LASER INTERFEROMETER GRAVITATIONAL WAVE OBSERVATORY
- LIGO -
CALIFORNIA INSTITUTE OF TECHNOLOGY
MASSACHUSETTS INSTITUTE OF TECHNOLOGY

Document Type LIGO-T960093-00 - D 7 Aug 96
Input Output Optics Design Requirements Document
initial Draft: Jordan Camp

Figure 2: Relation of IOO to other Detector subsystems

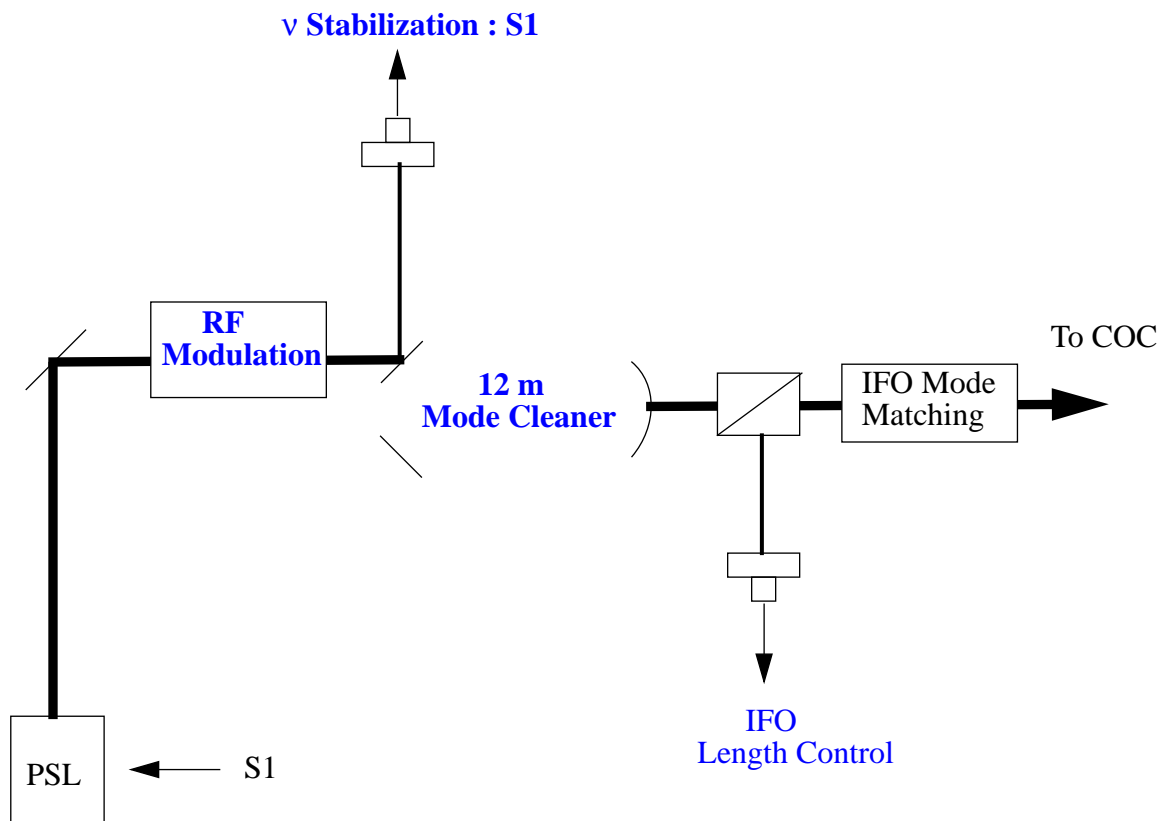
The Input Output Optics STILL CARRIES THE 'OUTPUT' IN THE NAME? primary function is to provide a filter of the PSL light so that it is of sufficient stability to be used as a measure of the LIGO arm cavity lengths. The IOO also is responsible to deliver the light with proper shape to resonate in the IFO, and to direct the IFO reflected light to the LSC and ASC subsystems. Finally, it appends and monitors the modulation sidebands used to derive signals in the length and alignment sensing and control subsystems. INTENSITY STABILIZATION OUTPUT SHOULD BE SHOWN; ASK PF IF THE ALIGNMENT REFLECTED LIGHT IS DETECTED ALSO WHERE YOU HAVE THE LENGTH DETECTED; SHOULD REMOVE PSL OR INDICATE THAT IT IS NOT PART OF THE TASK (GREYED OUT OR WHATEVER)
